Nepean Hospital Redevelopment Stage 1

*State Significant
Development
Modification Assessment
(SSD 8766 MOD 2)
October 2019*

Figure 4 | North-east view representation of the proposed development (Source: Modification Application)

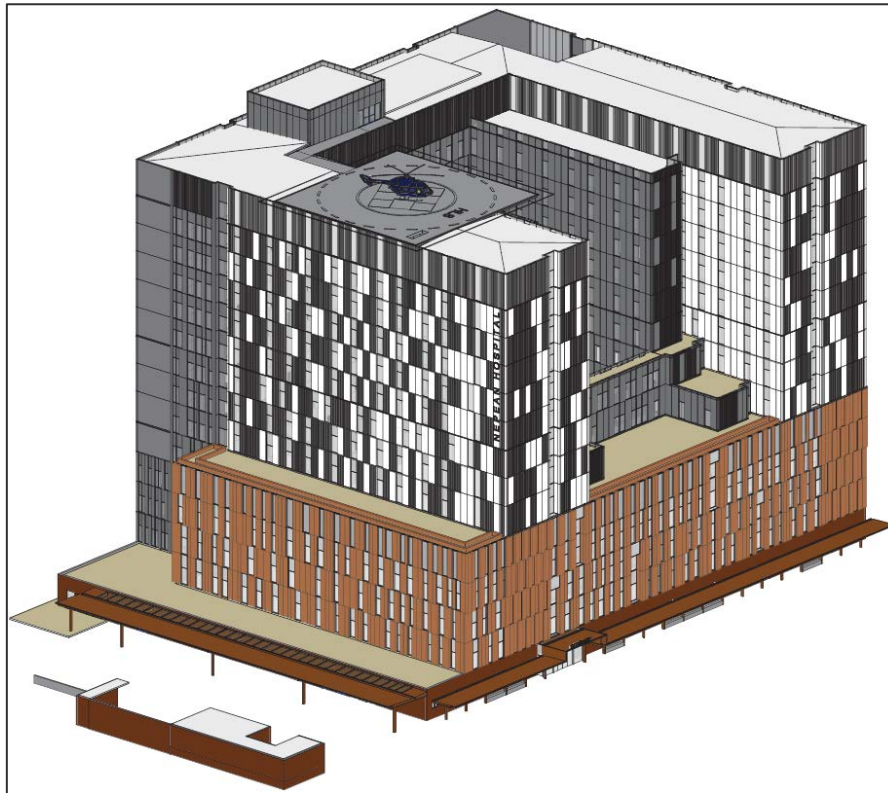
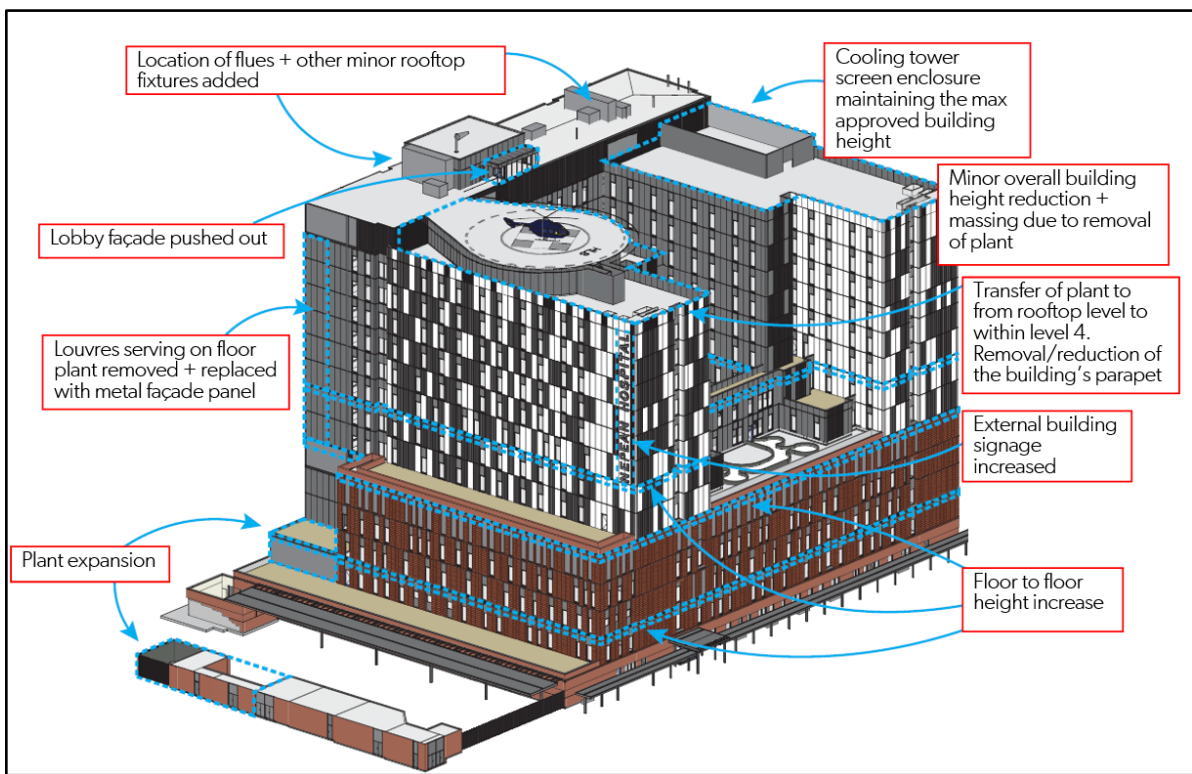
- relocation and consolidation of plant from the rooftop (Level 13) to lower levels of the building and resultant reduction of the building parapet.
- amendment to the helipad layout.
- indicative location of flues and other minor rooftop fixtures, including a helipad windsock.
- addition of a communications room to Level 1.
- increases to floor to floor heights:
 - Level 1 increased by 100mm to Level 2.
 - Level 4 increased by 300mm to Level 5.
 - Level 6 increased by 300mm to Level 7.
- façade amendments including changes to external materials, rooftop lobby façade changes and the addition of a temporary façade to the western elevation.
- amendments to external building identification signage.
- addition of a services access road.
- ancillary changes to landscaping and stormwater management.

Figure 8 | Proposed (left) and approved (right) Level 4 floor plan (Source: Modification Application)

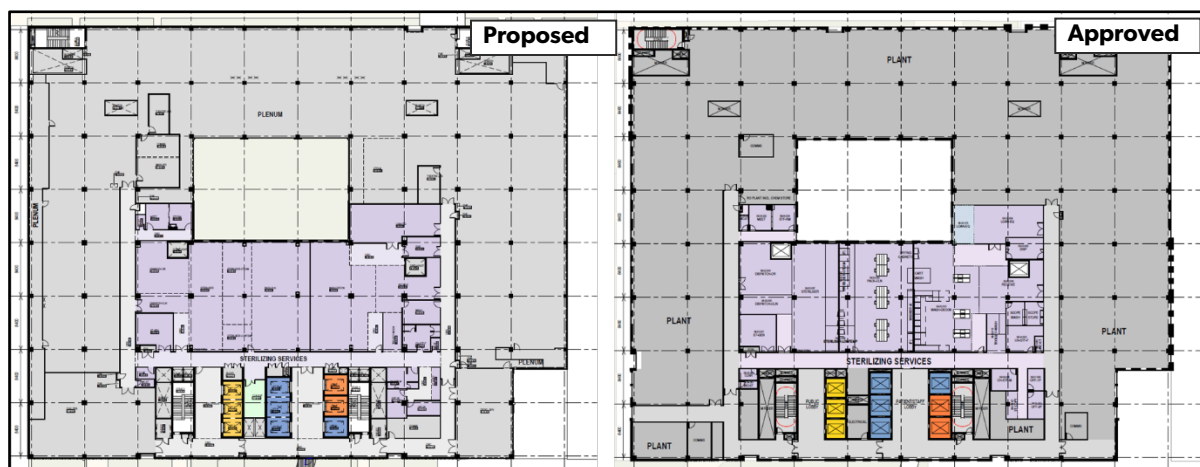
The application proposes to relocate the majority of plant from the rooftop level (Level 13) to lower levels within the building. To accommodate the relocated plant there are minor amendments proposed to the Level 4 internal plant layout and expansion of the external plant spine on Level 00 (see **Figures 7 and 8**).

Figure 10 | Proposed (left) and approved (right) overall site plan showing the proposed access road (Source: Modification Application)

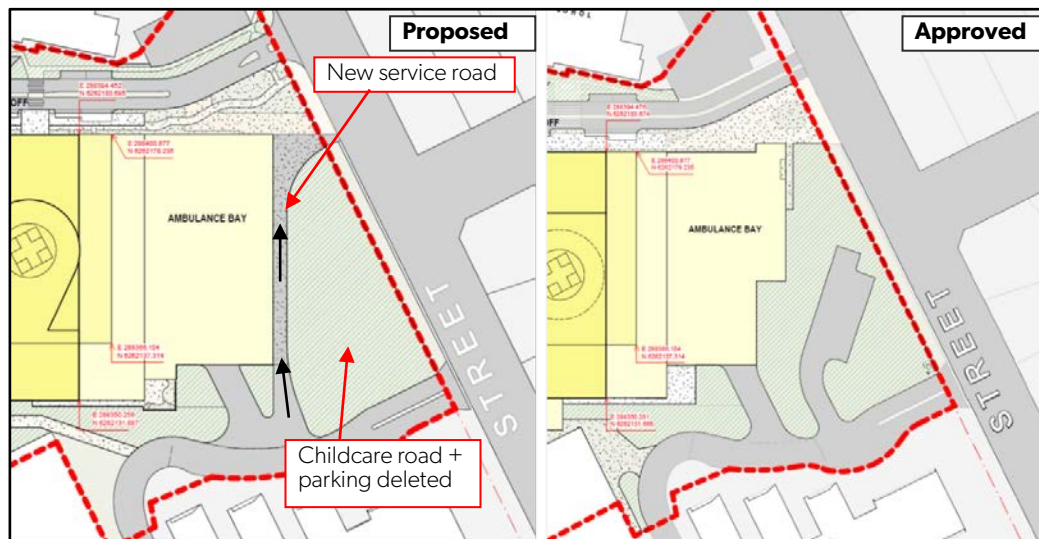
The proposal seeks to add a new service access road to the east of the building near the ambulance bay that will connect to Somerset Street (see **Figure 10**).

Issue	Findings	Recommended Condition
Services Road	<ul style="list-style-type: none"> The application seeks to create an access road for service vehicles, with access in and out of Somerset Street (Figure 10). The Applicant states this road is required due to clashing between the alignment of the permanent access road and existing child care centre. A transport statement from ptc has been provided which states the road will allow clear and safe vehicle movements separating public, ambulance and operational vehicles. At the Department's request, the Applicant provided further information relating to the use of the proposed access road. The Applicant advised that the services road will permanently support the external plant spine. A further statement from ptc was provided confirming there will no vehicular and pedestrian conflict 	<ul style="list-style-type: none"> The Department is satisfied that the proposed service road is acceptable as it would provide a dedicated and separate road away from the ambulance bay and would not result in any negative access impacts. The Department recommends the ptc signage plan is added to the consent.

- ptc recommended appropriate signage at the entry to the restricted areas, including the services road to advise the general public of no entry – authorised vehicles excepted and provided a plan indicating this.

Figure 11 | Proposed (left) and Approved (right) Western Elevation (Source: Modification Application and Approved Plans)

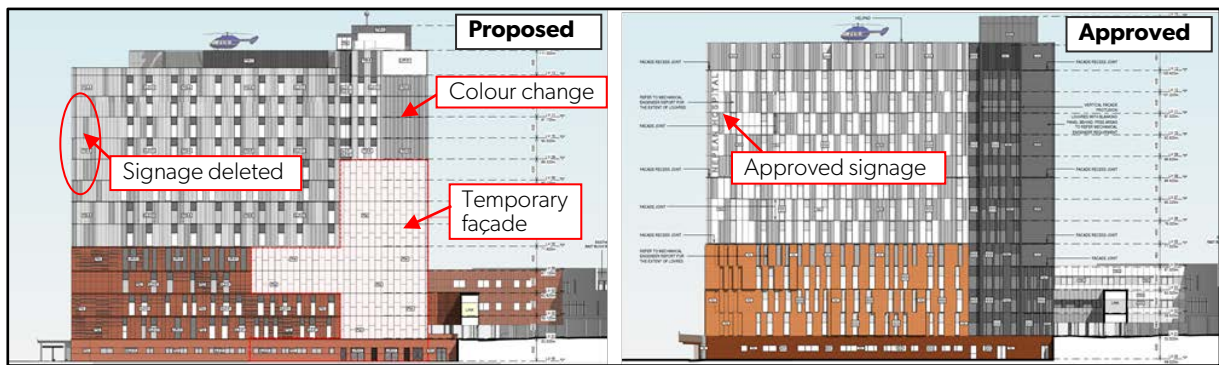
The proposal seeks to apply a temporary façade to an area of the western elevation to provide for future connection with the future pending Stage 2 redevelopment of the Nepean Hospital. The extent of the temporary façade area can be seen in **Figure 11** below. The proposal also seeks to augment windows on the southern elevation and change the colour of: the southern façade, south-west and south-east corners of the eastern and western façade and the link bridges to existing hospital blocks.

The proposal seeks to delete the external building identification signage on the western façade and increase the size of the signage on the eastern façade (**Figure 11** and **12**).

Figure 12 | Proposed (left) and Approved (right) Eastern Elevation (Source: Modification Application and Approved Plans)

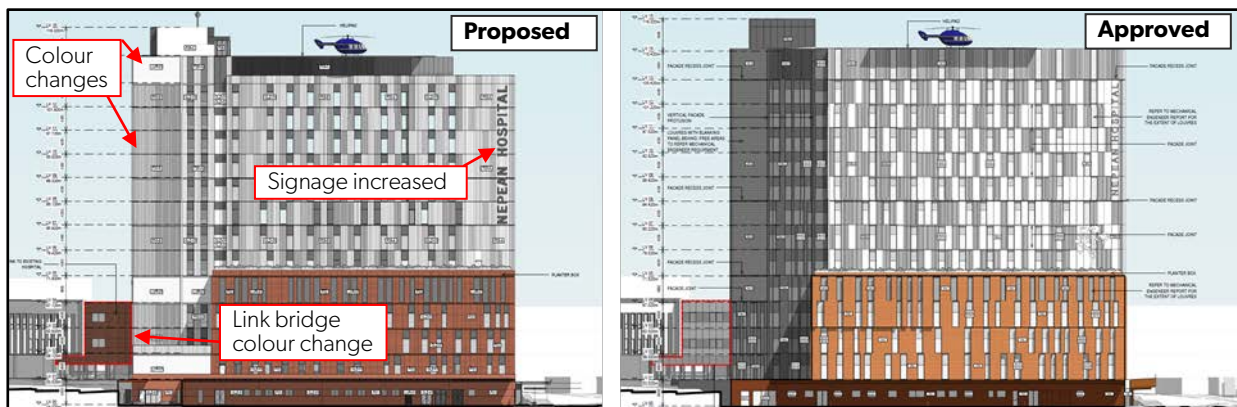
The Applicant further proposes to change the colour of façade on the western, eastern and southern elevations, and the link bridges to existing hospital buildings (see **Figures 11, 12 and 13**). The Applicant also seeks to change the grouping of windows along the southern façade. These changes are proposed as a result of further design work by BVN architects to improve the way the Stage 1 tower relates to the existing hospital campus. BVN considers the lighter façade colour ensures the existing hospital campus feels more connected to the new building and not excluded by feeling as if they are facing the ‘rear’ of the building.

Figure 13 | Proposed (left) and Approved (right) Southern Elevation (Source: Modification Application and Approved Plans)

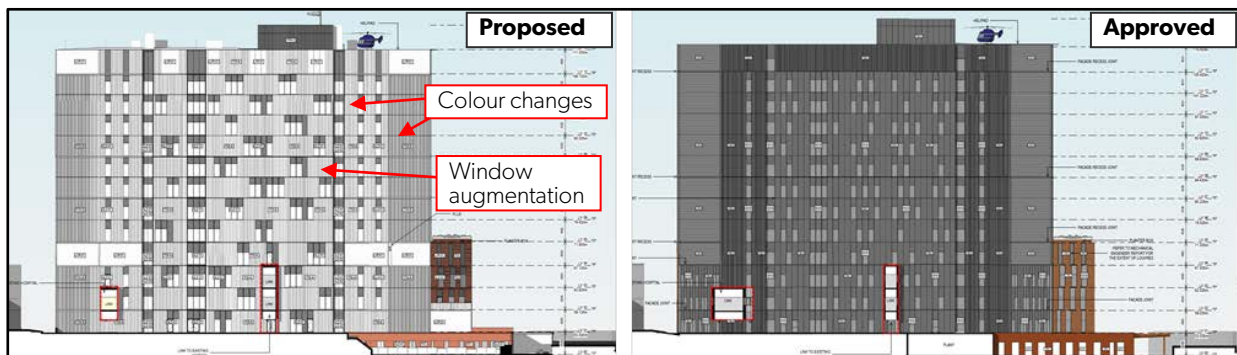
The Department considers that the lighter cladding, notably on the southern elevation would reduce the visual dominance of the tower over the existing hospital campus and improve the experience of users of the southern courtyard by providing a brighter outlook in this area. The proposed window groupings along the main public corridor would facilitate views over the landscaped southern courtyard area and existing hospital campus. The Department also considers the proposed link bridge facade colour is appropriate as it adds visual interest while maintaining a connection with the terracotta colour used on the tower podium.

Figure 14 | Proposed (left) and Approved (right) Western Elevation (Source: Modification Application and Approved Plans)

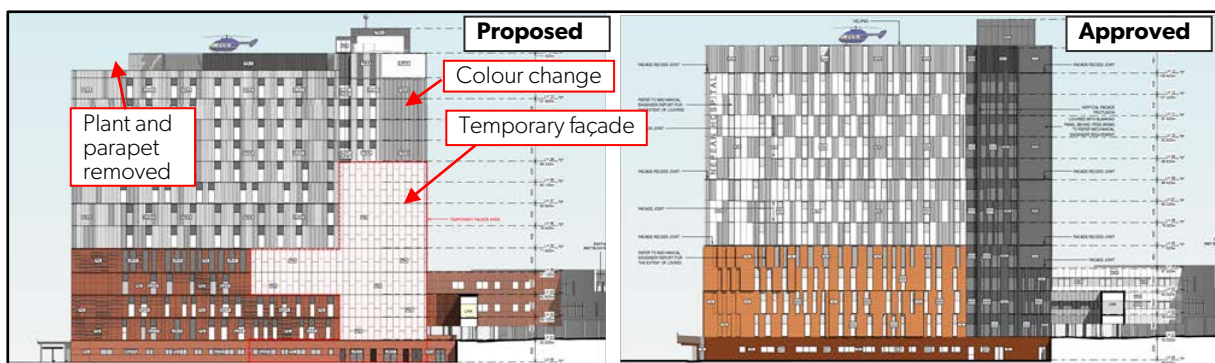
- replacing the louvres across Levels 5 to 12 with metal façade panels.
- adding a temporary façade to the western elevation (**Figure 14**).
- minor façade adjustments including, amendments to the placement and extent of windows and variations to glazing and cladding colours.
- amendments to the variations of glazing.

The Department notes that the temporary façade on the western elevation is sought to provide for future connection with the pending Stage 2 hospital redevelopment. The Applicant's justification for this is that the temporary façade will facilitate the proposed Stage 2 redevelopment in the most efficient and resource conscious manner. The Department sought further information from the Applicant on the indicative timing of the Stage 2 redevelopment. The Applicant has indicated that, subject to planning approval, the construction of

The Department notes that the Material Sample Board indicates that the proposed temporary façade material (F04) is to be removed in part or completely, depending on the requirements at the completion of the proposed future Stage 2 redevelopment works interfacing with Stage 1. The Applicant stated the temporary façade material is to ensure acoustic, fire, thermal, weather, infection protection and separation to enable clinical functions to continue unimpeded throughout the construction phase.

Overall, the Department considers the proposed façade is acceptable as it is temporary and allows the building to be responsive and efficiently connect with any future Stage 2 building. To ensure greater certainty around timing, the Department recommends a condition requiring the Applicant, within 36 months after the commencement of operation, to return any sections of the temporary façade that are not required for connection to any future building, to the permanent façade materials and finishes shown on plan A0-305 prepared by BVN dated 27/9/2019 (see **Figure 16**).

Figure 15 | Proposed (left) and approved (right) Level 1 floor plan (Source: Modification Application)

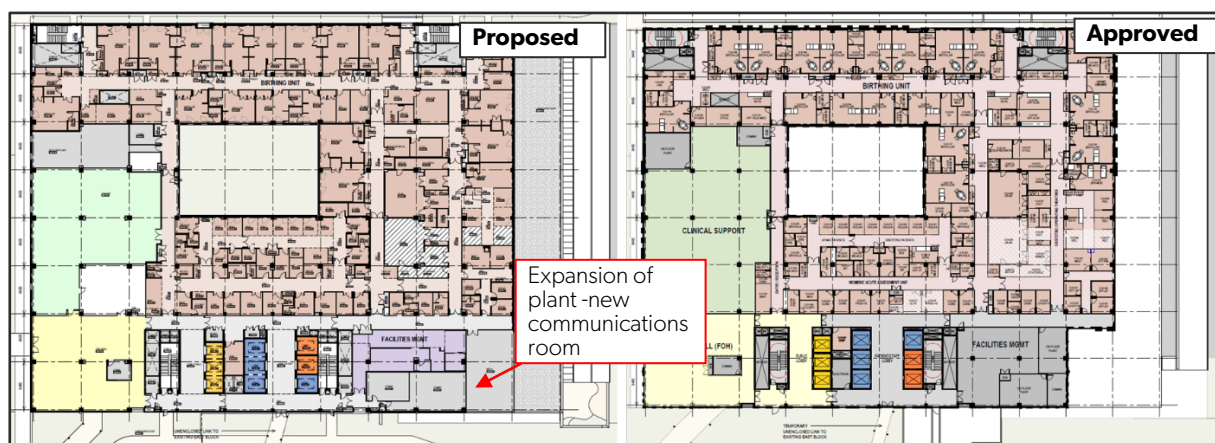
The modification also seeks to add a new communications room on the south-east corner of Level 1 (see **Figure 15**). The Applicant states that the proposed room and slight increase in the on-floor mechanical plant would enable the efficient servicing of the adjacent birthing section.

Other internal alterations proposed to the development, including the addition of a new communications plant room on Level 1 are considered to be of minimal impact and remain consistent with the appearance of the originally approved development. Furthermore, the new plant room does not generate any additional Gross Floor Area (GFA) due to the definition of GFA in the PLEP (2010). As such, the Department considers these modifications to be acceptable.

Figure 17 | Proposed (left) and Approved (right) landscape plan (Source: Modification Application)

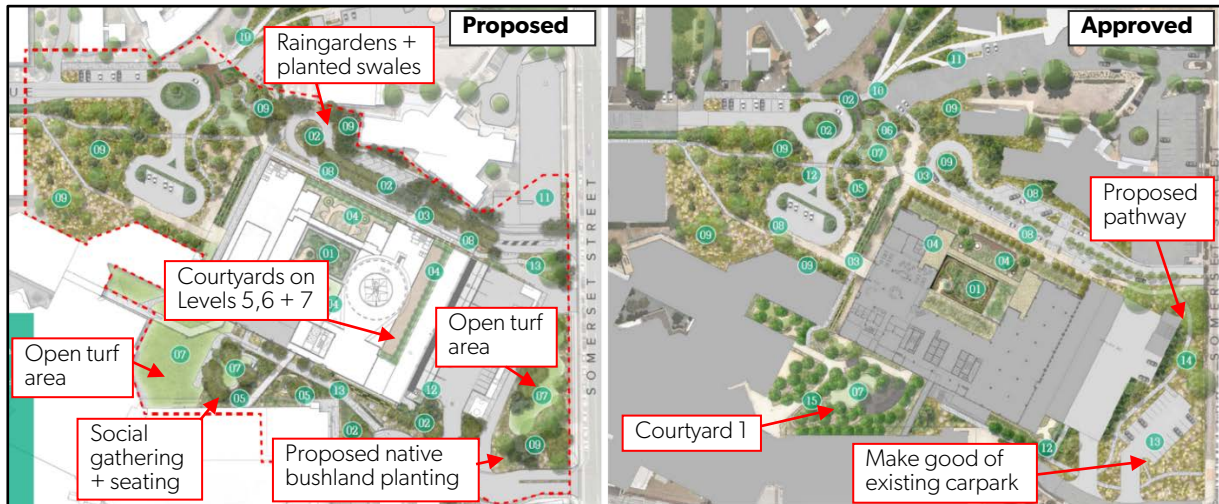
- requesting a detailed landscaping design for the area to the east of the site between the building and Somerset street, a plant schedule and arborist report.
- seeking details around the use and function of 'courtyard 1', existing trees identified for removal and details around the purpose of the oval roundabout in the forecourt area.
- stating that accessible paths should be provided and indicated.

- relocating the landscaped area from Level 6 to Level 5 of the building to correct a plan reference anomaly.
- provision of additional accessible landscaped space on Levels 6 and 7.
- modifications to landscaping design around the building (see **Figure 17**).

Figure 18 | Proposed landscape area near Somerset Street (Sheet 107) (Source: RtS)

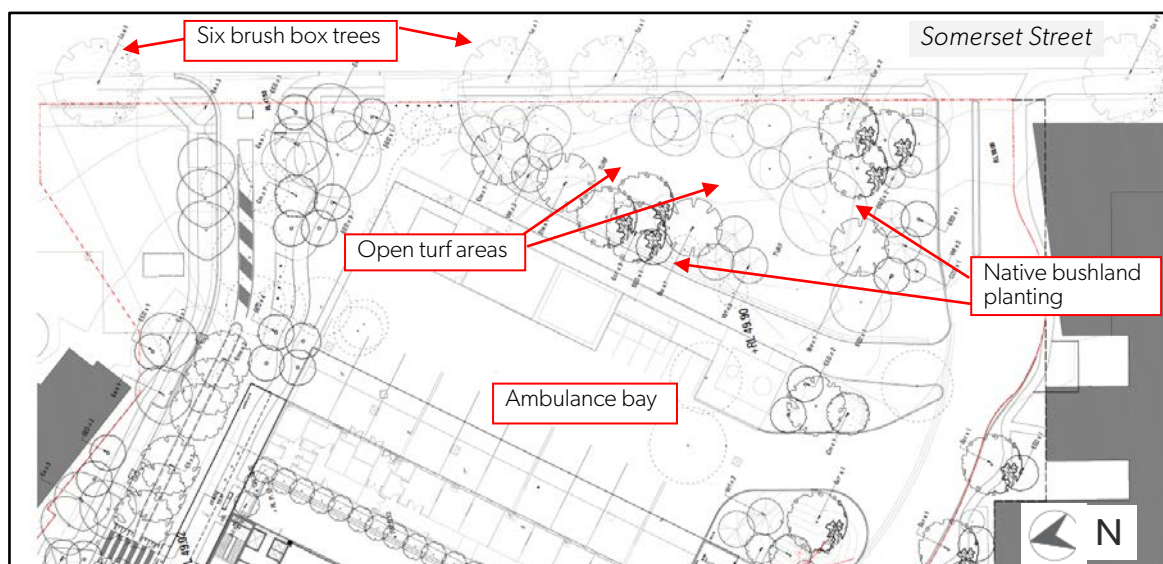
At Council's request, the Applicant in its Response to Submissions (RtS) provided a detailed landscape sheet (see **Figure 18**) to cover the new landscaped streetscape area and updated the plant schedule. The RtS also proposed the addition of six, 400 litre specimens of Brush Box along Somerset Street in accordance with Council's 'Kingswood Public Domain Technical Manual.'

The Department has taken into consideration Council's submission and the response provided in the Applicant's RtS and considers that this proposed landscape area is appropriate as it provides increased landscaping to the site, while acknowledging its location between the ambulance bay and the street.

The Department's existing conditions of consent includes condition B39, which requires the Applicant to consult with Council and demonstrate to the Certifying Authority that the streetscape design and treatment meets the requirements of Council, including addressing pedestrian management.
